METROPOLITAN GOVERNMENT OF NASHVILLE AND DAVIDSON COUNTY

STAFF RECOMMENDATION 1211 Seventh Avenue North August 16, 2017

Application: New construction—infill
District: Germantown Historic Preservation Zoning Overlay
Council District: 19
Map and Parcel Number: 08213016000
Applicant: Michael Emrick, architect
Project Lead: Melissa Baldock, melissa.baldock@nashville.gov

SITE PLAN
1" = 10' - 0"

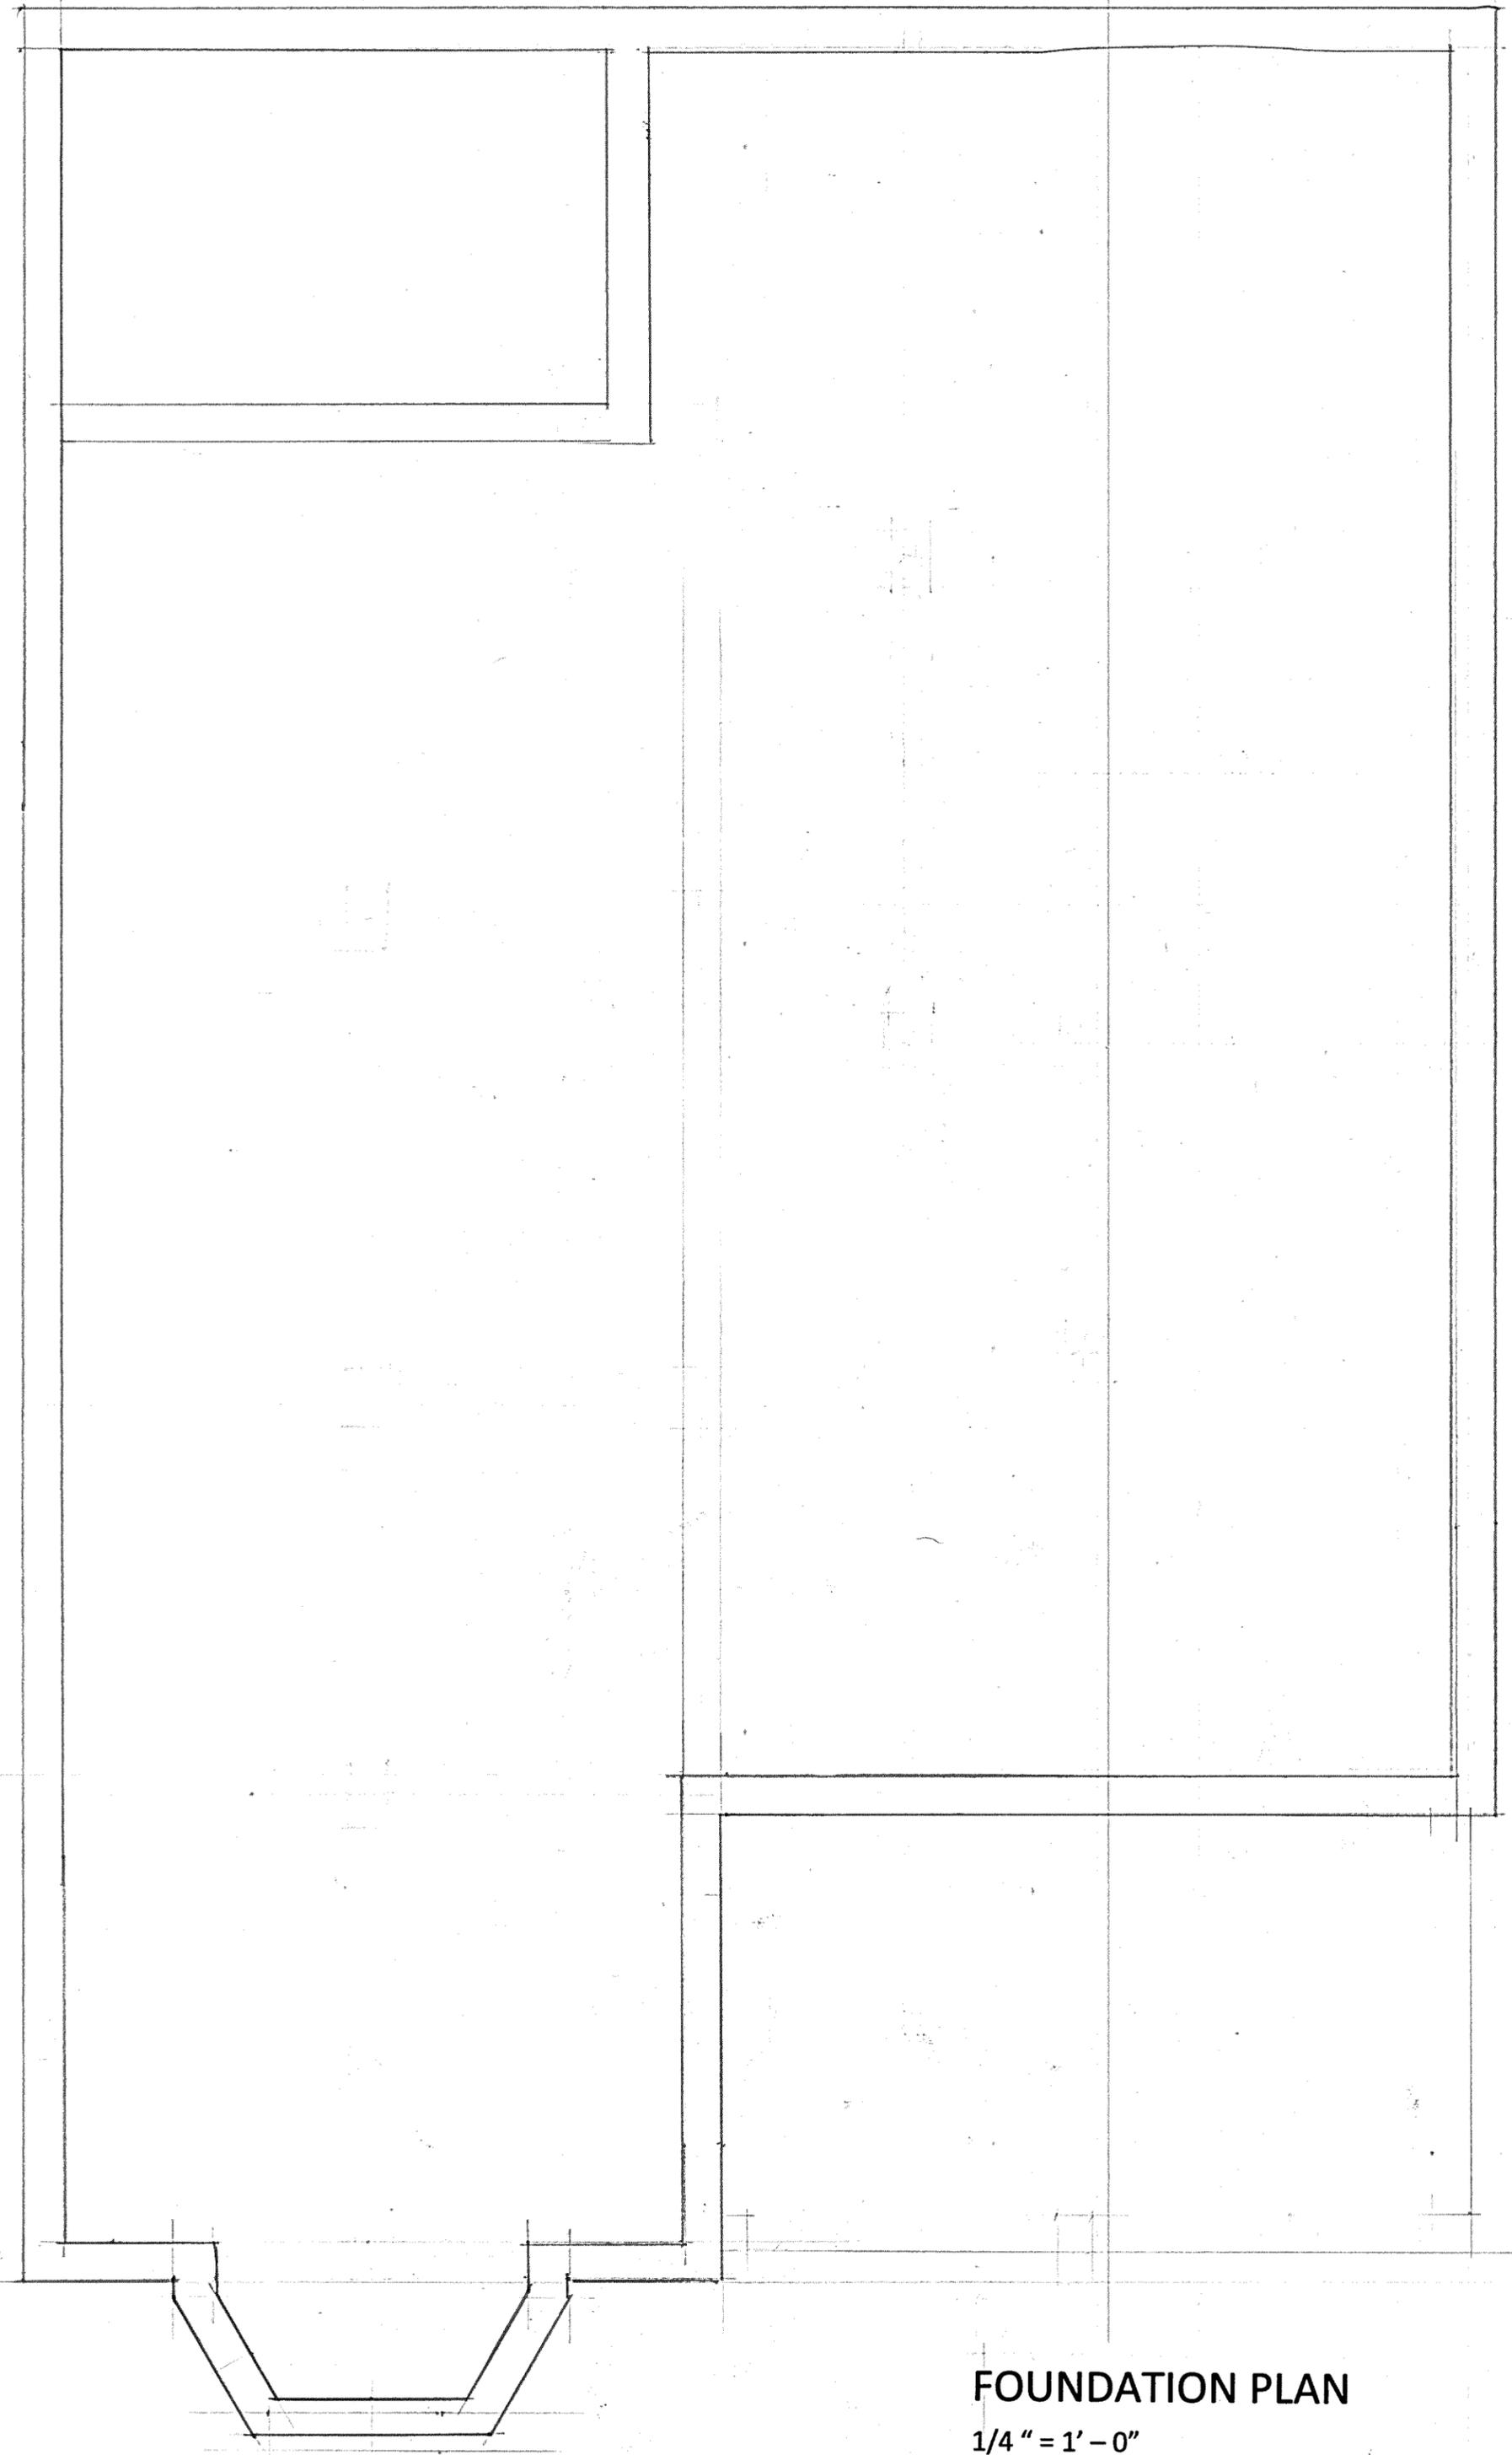
Setbacks. The proposed infill meets all base zoning setbacks. It will be a minimum of five feet (5') from the side property lines, and will be close to seventy-five feet (75') from the rear property line. The infill's projecting two-story bay will sit as close as eleven feet, six inches (11'6") from the property line. The main wall of the front façade will sit approximately fifteen feet, nine inches (15'9") from the front property line. Staff finds the front setback to be appropriate. On either side of the lot are vacant properties. The nearest historic houses are 1207 7th Avenue North and 1215 7th Avenue North; 1207 7th Avenue North sits approximately three to four feet (3'-4') from the front property line and 1215 sits about twelve feet (12') from the front property line. Staff finds that the proposed front setback is appropriate given the context, but recommends that the Commission staff approve the front setback when it is staked in the field to ensure its appropriateness. Staff also recommends that the front setbacks of 1207 and 1215 7th

Avenue North be added to the site plan. With these conditions, staff finds that the proposed setbacks meet Section 2.2.1 of the design guidelines.

Utilities/Mechanical. No location for the mechanicals and utilities were indicated on the site plan, and staff recommends that they be placed at the rear, or on a side façade behind the midpoint of the house.

Fences, walls, and other appurtenances. No fencing, walls, or other appurtenances were indicated on the site plan. Staff recommends review and approval of all fences, walls, and other appurtenances to ensure that they comply with Section 5.0 of the design guidelines.

1. Staff approve the front setback when it is staked in the field;
2. The finished floor height be consistent with the finished floor heights of neighboring historic houses, to be verified by MHZC staff in the field;

10. The HVAC be located behind the house or on either side, beyond the mid-point of the house; and
11. Staff approve the design and materials of all permanent landscape features, including the fences, walls, pavers, walkways, etc.

EAST ELEVATION

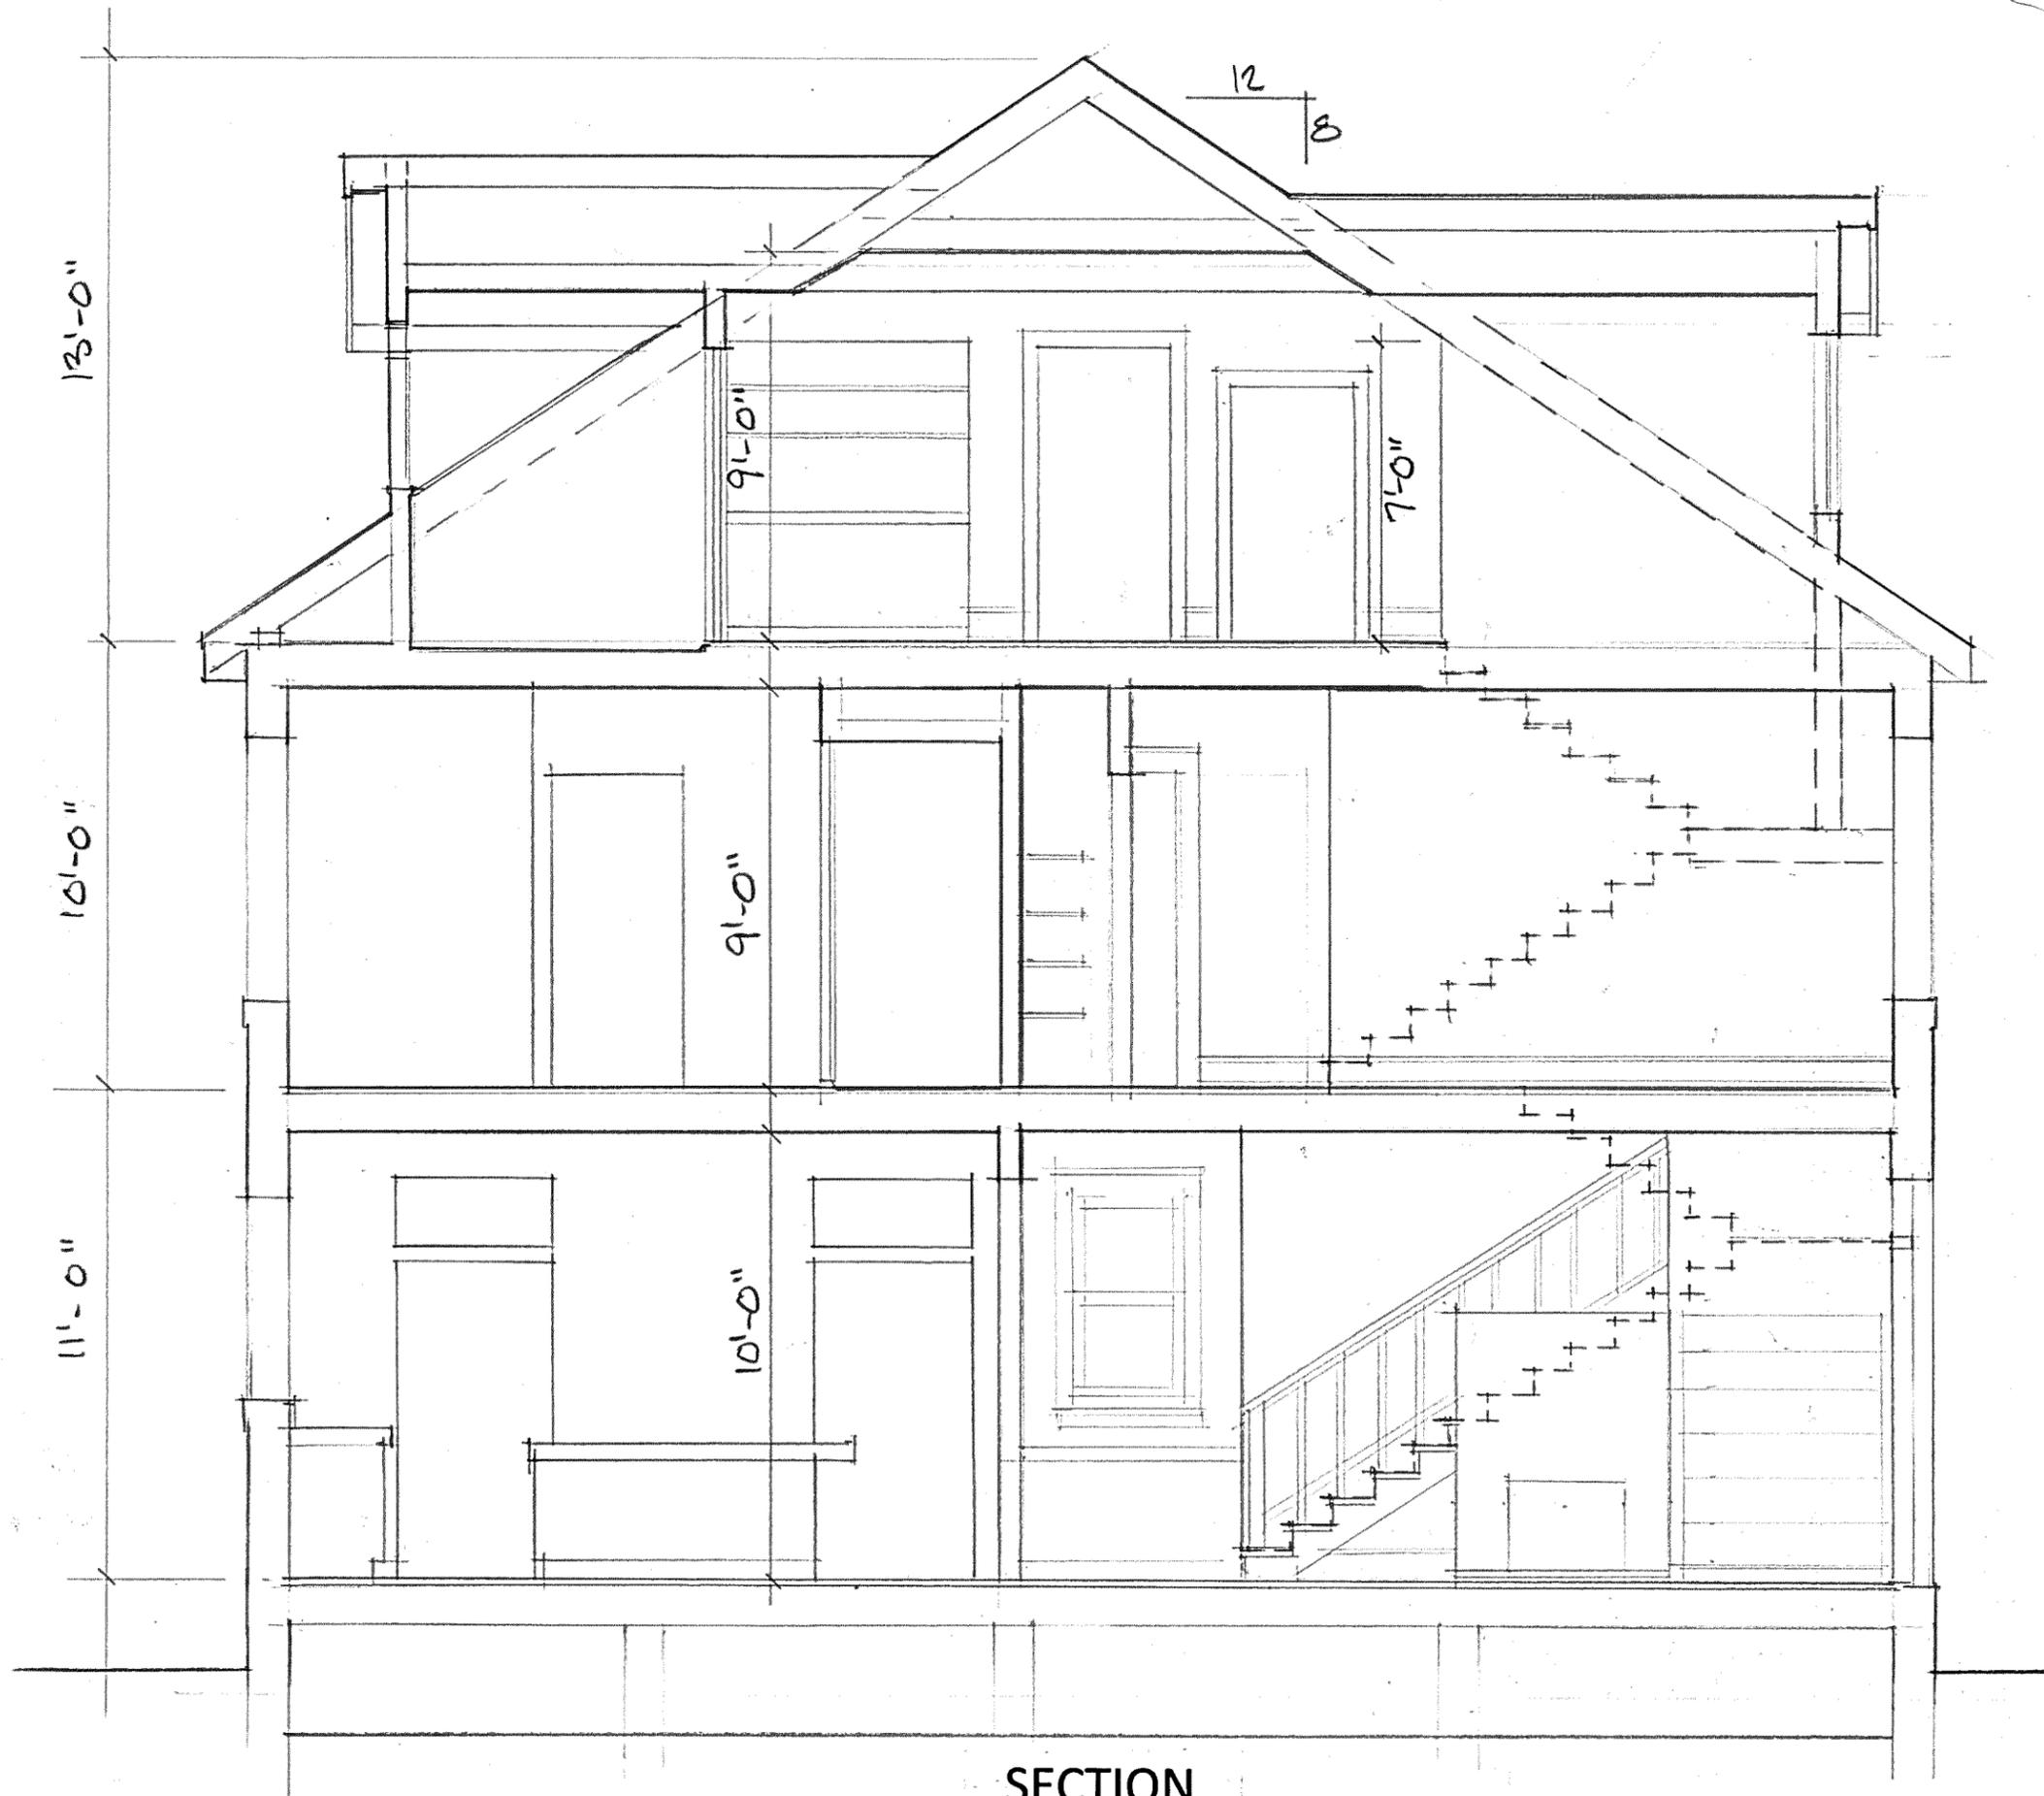
The proposed infill is a maximum height of thirty-five feet (35') above the foundation line and thirty-seven feet (37') from grade. The design guidelines limit the height of new, single family infill houses to thirty-five feet (35'). The Commission has interpreted this guideline to limit the height to thirty-five feet (35') from grade. Staff therefore recommends that the height of the infill be reduced by two feet (2') so that it is no more than thirty-five feet (35') tall from grade.

The proposed infill's windows are general twice as tall as they are wide, thereby meeting the historic proportion of window openings. There are no large expanses of walls without a window or door opening. The double window openings are not drawn with four to six inch (4"-6") mullions in between them. Staff recommends that all paired window openings have a four to six inch (4"-6") mullion in between them. The right-side elevation includes French doors with exterior railings. This is typically not appropriate because it creates a version of a Juliet balcony that appears to be flat to the wall rather than projecting; however, the minimally visible location makes this proposal appropriate. With the mullion condition, staff finds that the proposed windows and doors meet Sections 2.5. and 2.6. of the design guidelines.

Porches and Entrances. The primary entrance will be behind a front porch that is ten feet (10') deep. The main porch roof is flat, and the roof of the porch can be accessed via a second story double door. Since the second balcony at the roof is uncovered, staff finds it to be appropriate and to meet the design guidelines. Staff finds that the proposed porch and front entrance meet Section 2.6 of the design guidelines.

Roof. The primary roof form will be a hipped roof with an 8/12 pitch. The front projecting bay will be a gable with an 8/12 pitch. The two side dormers will also be gabled with an 8/12 pitch. These dormers are inset two feet (2') from the wall below and are set three feet, six inches (3'6") off of the roof ridge, keeping the scale of the dormers appropriate. The dormer on the left façade will contain an open balcony rather than windows and walls. The Commission has found dormer balconies to be appropriate in the past when the dormers have been appropriately scaled. In addition, this dormer is located on the side elevation where it will not be highly visible. Staff finds that the proposed roof forms meet Section 2.7 of the design guidelines.

3. The infill be lowered in height so that it is no taller than thirty-five feet (35') from grade;
4. All paired window openings have four to six inch (4"-6") mullions in between them.
